Santa Maria Public Airport District
Parking Lot and Apron Rehabilitation
Addendum No. 2

Contractors interested in bidding the work of this project are hereby notified of the following additions, deletions, changes, revisions, and/or modifications to the Plans and Specifications for this project.

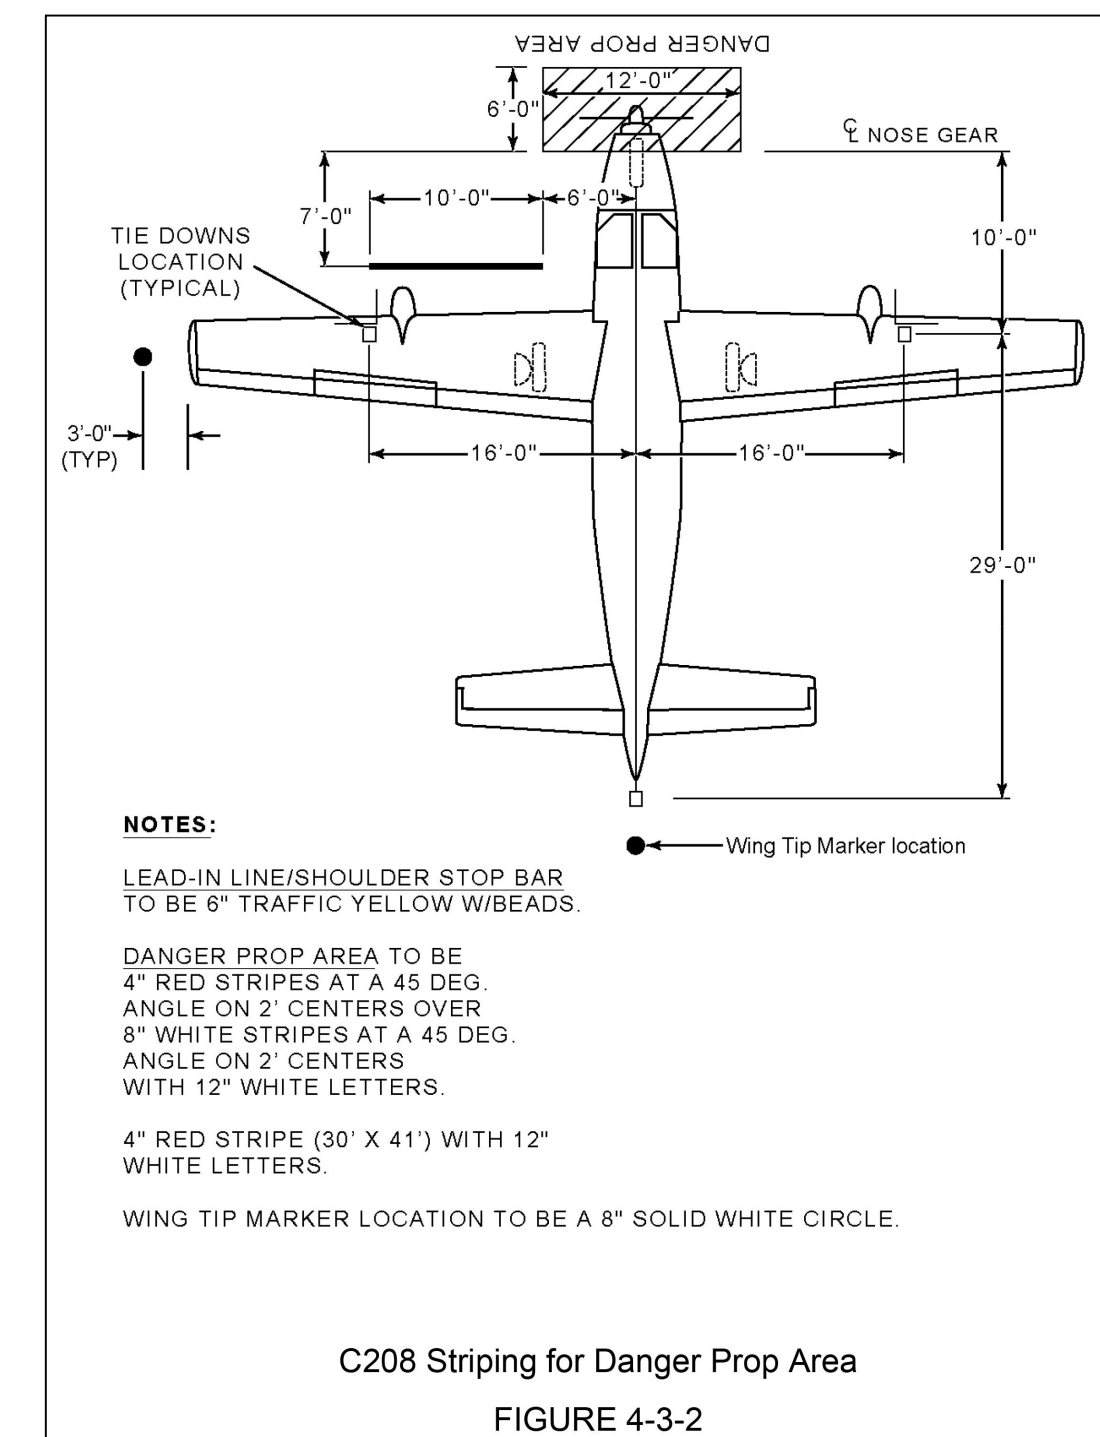
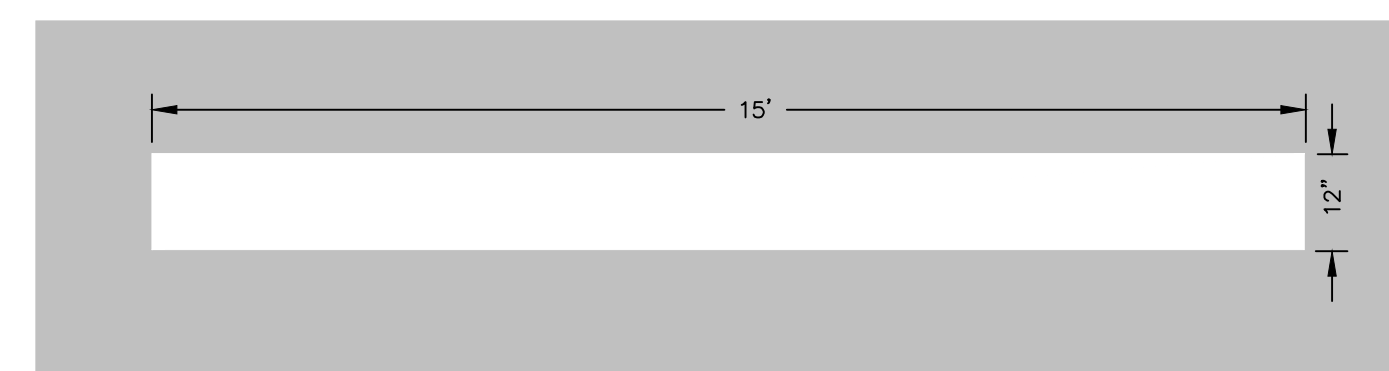
- 1.04 Sheet 13 of the plan set has been revised to show new apron tie-down markings. Revised Sheet 13 is included in this addenda as an attachment.
- 1.05 Sheet 15 of the plan set has been revised to include details pertaining to the apron tie down markings. Revised Sheet 15 is included in this addenda as an attachment.
- 1.06 Three new sheets are included as an attachment to this addendum. These new sheets are from the solar structure project to be completed before the start of construction of this project.
- 1.06.1 Sheet E1.0, Collins Electric: Shows overall photovoltaic canopy structures within parking lot.
- 1.06.2 Sheet E1.0, Collins Electric: Tartaglia modified to include the remove and reconstruct areas.
- 1.06.3 Sheet S300, Collins Electric: Shows the typical section (height) of solar canopies.

(DEMOLITION PLAN SHEETS 3, 4, 5, 6)

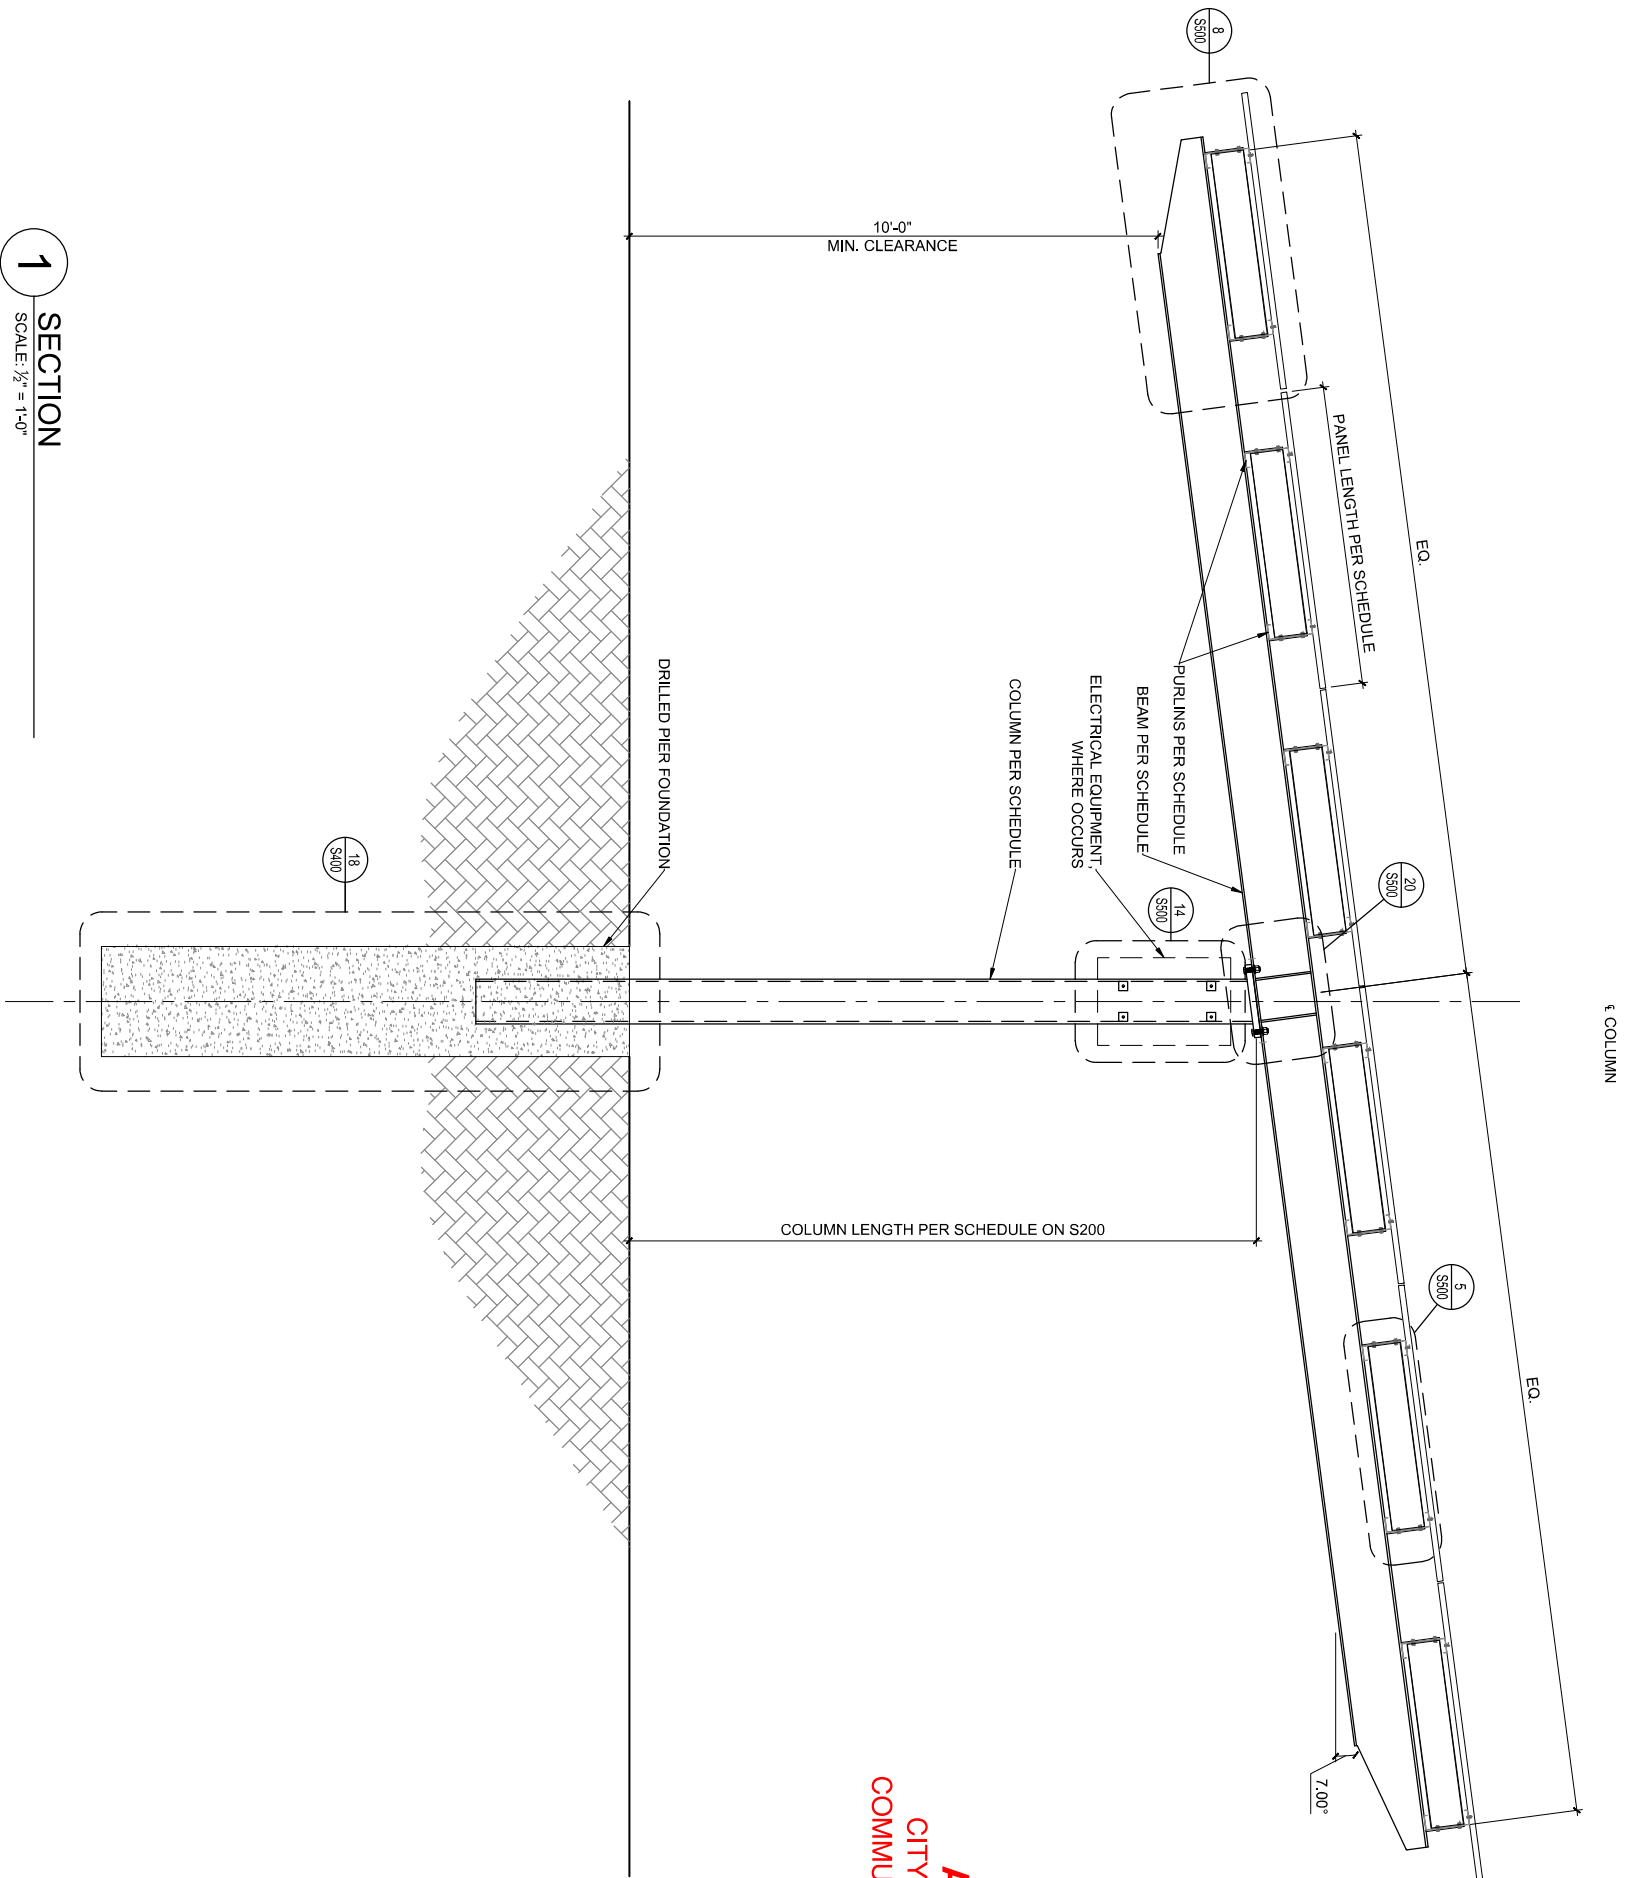
- 1.07 It seems the dig out overlay on the solar plans did not make it to the Public Purchase site to download? Please advise. Thank you.
Answer: The overlay plan was mistakenly left out of the last addendum. It is now attached to this addendum (Item 1.06.2).
